UNITED STATES OF AMERICA
NUCLEAR REGULATORY COMMISSION

In the Matter of:)	Docket No. 72-22-ISFSI
PRIVATE FUEL STORAGE, LLC)	ASLBP No. 97-732-02-ISFSI
(Independent Spent Fuel)	
Storage Installation))	April 1, 2002

**STATE OF UTAH'S PREFILED TESTIMONY ON
UNIFIED CONTENTION UTAH L/QQ - GEOTECHNICAL**

Figure 9. Laboratory Tests Commonly Performed to Determine the Anisotropy of the Soil (after EPRI 1990).

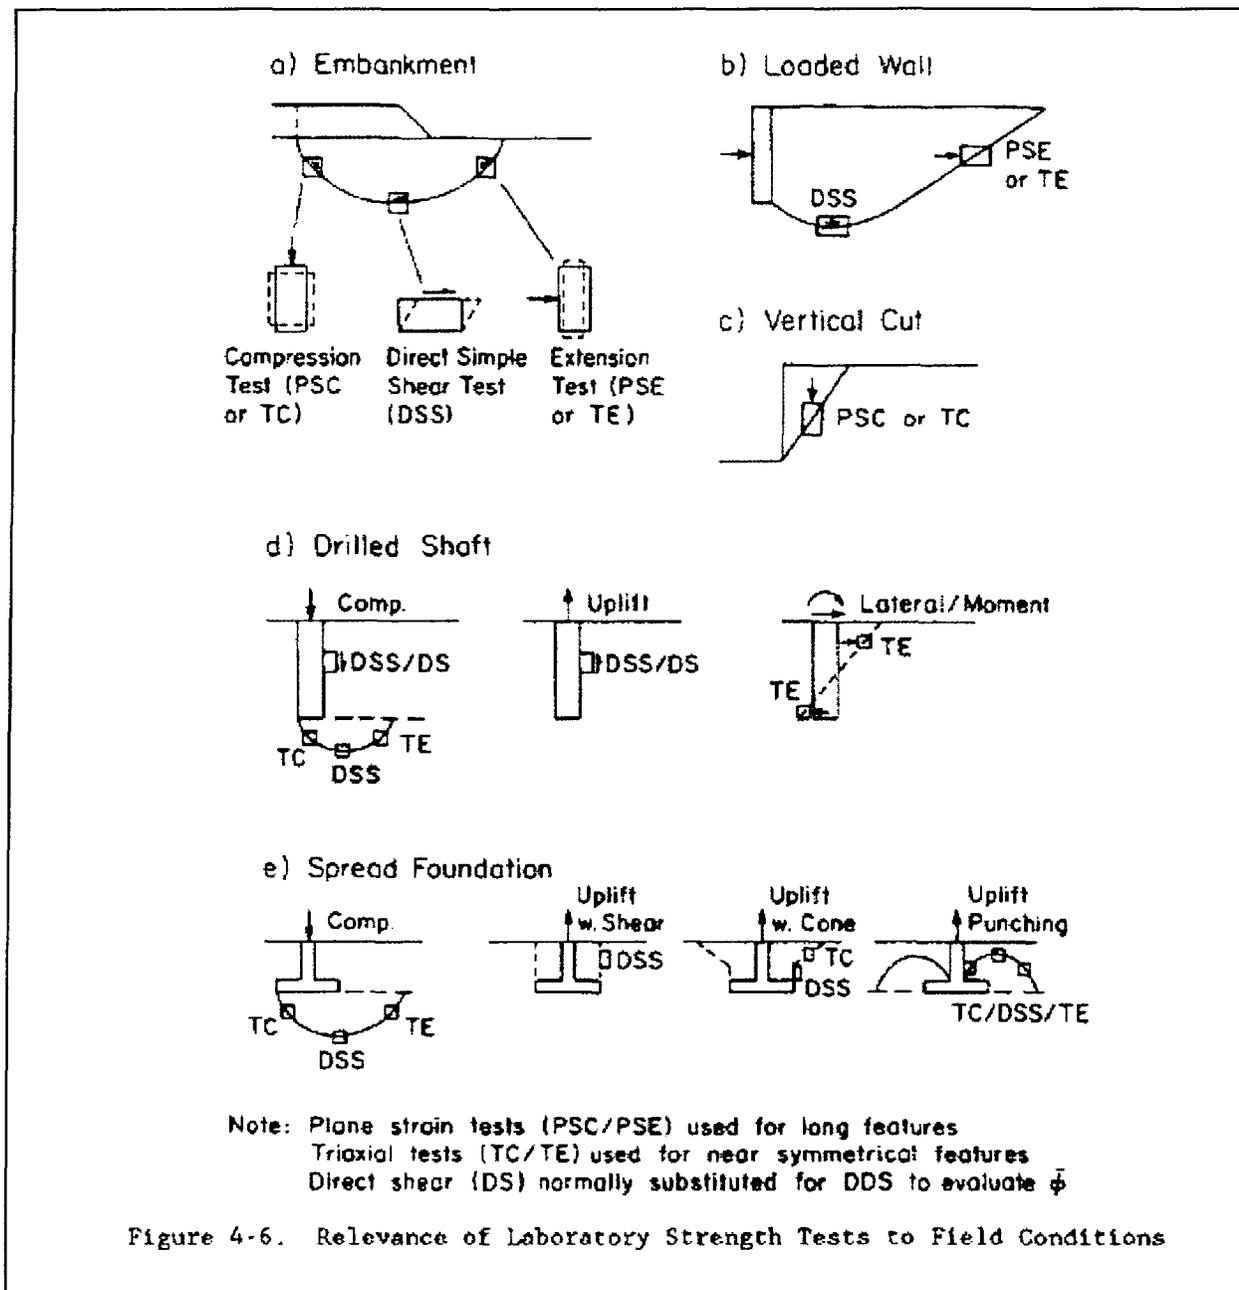
A. 32: Yes. The upper Lake Bonneville sediments have anisotropic shear strength properties. This means that the shear strength is a function of the direction of shear (State's Exhibit 103, Figure 9¹¹). The upper Lake Bonneville sediments are strongest in triaxial compression ("TC") and weakest in triaxial extension ("TE"). They have intermediate shear strength values when tested in direct simple shear ("DSS"). Previous studies performed on Lake Bonneville sediments have shown that the undrained shear strength in triaxial extension is approximately 60 percent of the undrained shear strength in triaxial compression (Saye and Ladd, 2000, p. 11)¹².

The Applicant has primarily used triaxial compression tests to calculate the soil's resistance to bearing capacity failure. No consideration has been given to performing triaxial extension tests to determine the degree of anisotropy of the foundation soils. If significant anisotropy is present, then the use of triaxial compression tests is unconservative and overestimates the average shear resistance along the potential failure plane (State's Exh. 103,

Figure 9 e). This issue has the greatest significance in analyzing the bearing capacity of the storage pads, due to their relatively narrow width (30 feet) and the small margin (i.e., 5 percent) against seismic bearing capacity failure estimated by the Applicant.
